# UNITED STATES PATENT AND TRADEMARK OFFICE

<b>Office Action Summary</b>	Application No. 10/723,126	Applicant(s) GILBREATH, DONALD R.	
	Examiner Aaron M. Dunwoody	Art Unit 3679

## DETAILED ACTION

the collar support portion including *a spline* and an axial stop ring (see Figure 4 below),

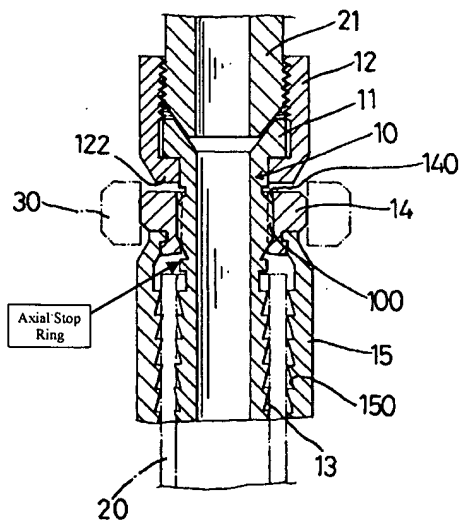
In regards to claims 1 and 2, Huang discloses an improved hydraulic fitting having a stem (10) including a hose insert portion, and a collar support portion, having a mating connection portion, and a collar having, a torque communication portion, a female support portion, and an inner periphery extending through the ferrule support portion and the torque communication portion, the improvement comprising:

Applicant argues that Huang fails to disclose at least said collar support portion including an axial stop ring. The Examiner disagrees. As illustrated above, Huang clearly illustrates at least said collar support portion including an axial stop ring.
